ROTHER DEVELOPMENT AND SITE ALLOCATIONS LOCAL PLAN

SCHEDULE OF MAIN MODIFICATIONS AND CHANGES TO POLICIES MAPS

July 2019

Figure 4b | Illustrative plan showing modified FAC2 allocation and Fairlight development boundary [MM26] [PMM5]

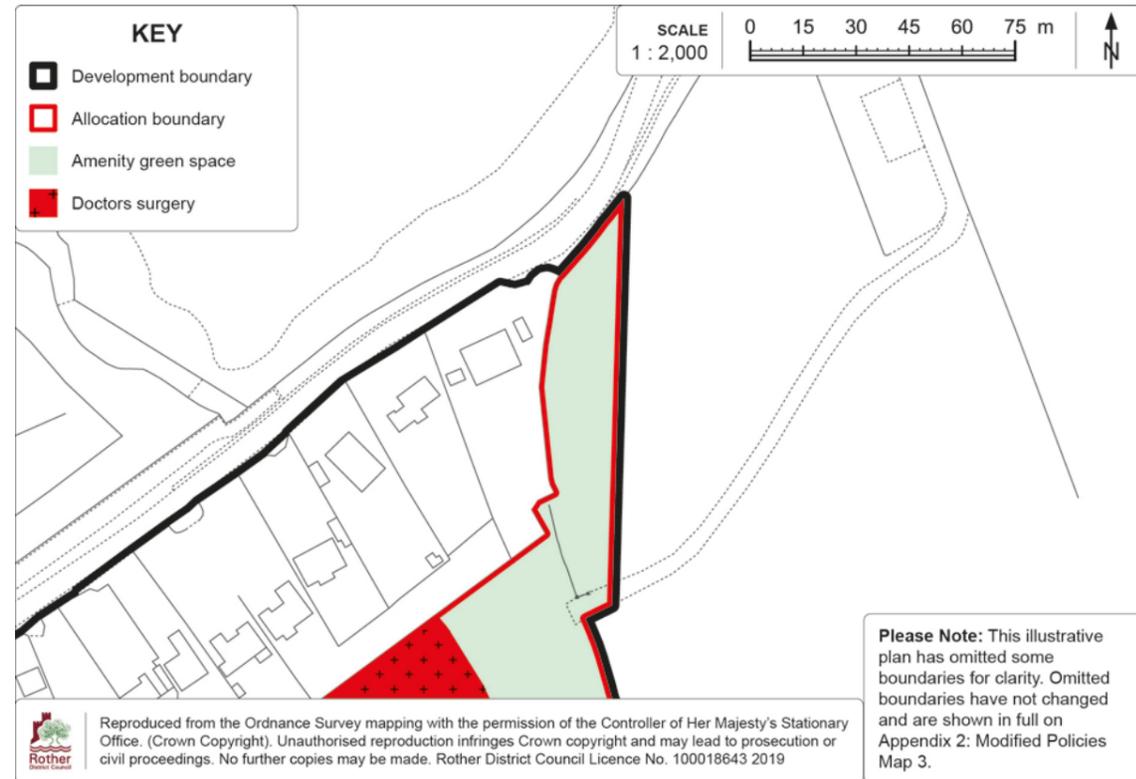
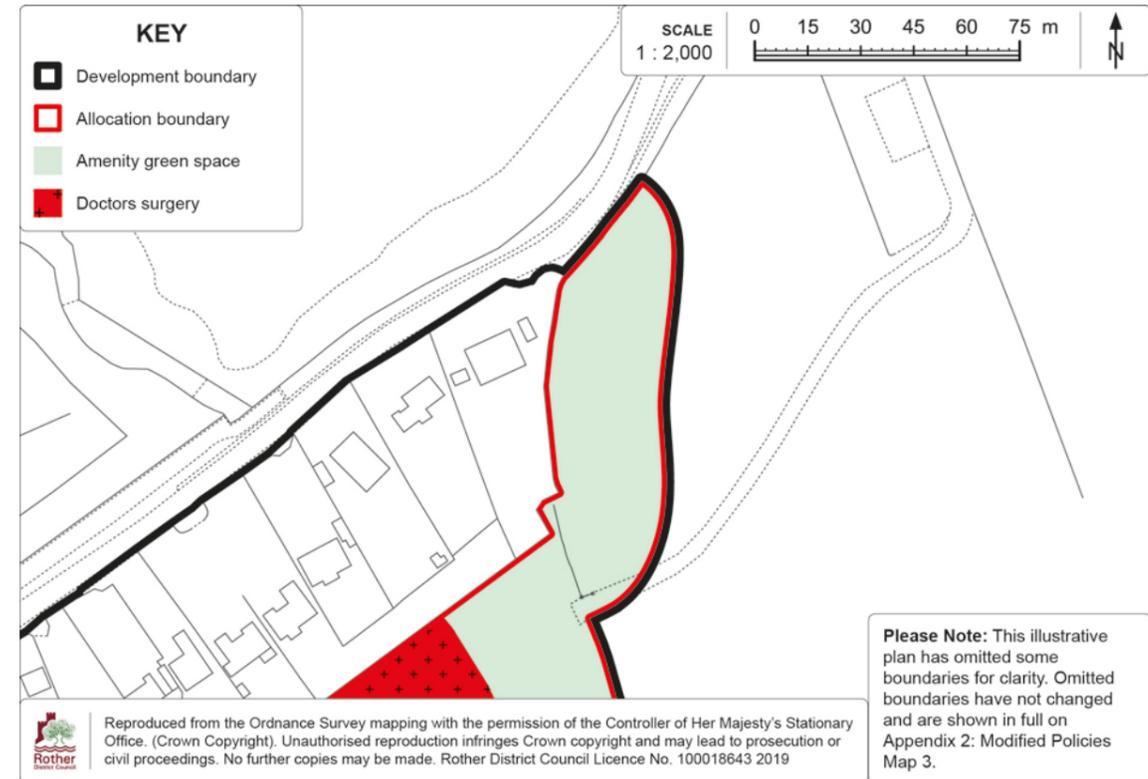
MM26	Amendment to Detail Map supporting Policy FAC2 and the Policies Map to move the boundary of the proposed access.	Figure 50: Policy FAC2 Detail Map	It is necessary to increase the size of the site to include a greater amount of land along the proposed access. Move the boundary to the east of the proposed access approximately 10m further east. Policies Map Inset Map 9: Fairlight Cove has also been updated in this regard. <u>Please see Appendix 1: Modified Detail Map 4</u>	To ensure that the site access is of an adequate size to accommodate a sufficient alignment together with acceptable visibility splays.
		Policies Map Inset Map 9: Fairlight Cove	In line with the modification to Figure 50: Policy FAC2 Detail Map (above), it is necessary to increase the size of the site area for FAC2 to include a greater amount of land along the proposed access. Move the boundary to the east of the proposed access approximately 10m further east and move the development boundary to be in line with this. Figure 50: Policy FAC2 Detail Map has also been updated in this regard. <u>Please see Appendix 2: Modified Policies Map 3 for the amended Policy Map Inset Map.</u>
